# MILITARY SPECIFICATION SHEET SYNCHRO CONTROL TRANSMITTER, TYPE 31CX60

MIL-S-20708/139(NAVY)
AMENDMENT 2
9 September 1992
SUPERSEDING
AMENDMENT 1
25 September 1975

## SYNCHRO, CONTROL TRANSMITTER, TYPE 31CX6A

## PAGE 1, Change 3

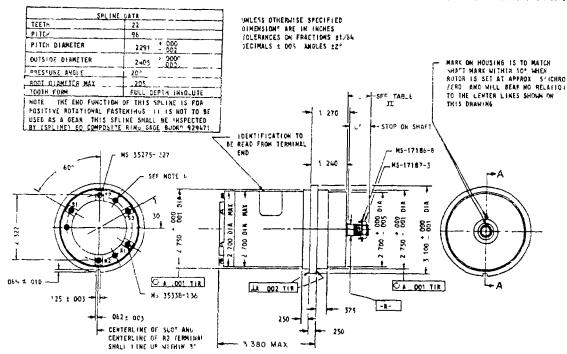
Outline drawing, flange diameter designation 3 100 (+000 - 00!) Delete the tolerance "(+.000 - 00!)" and substitute the tolerance "(+.000 - .005)."
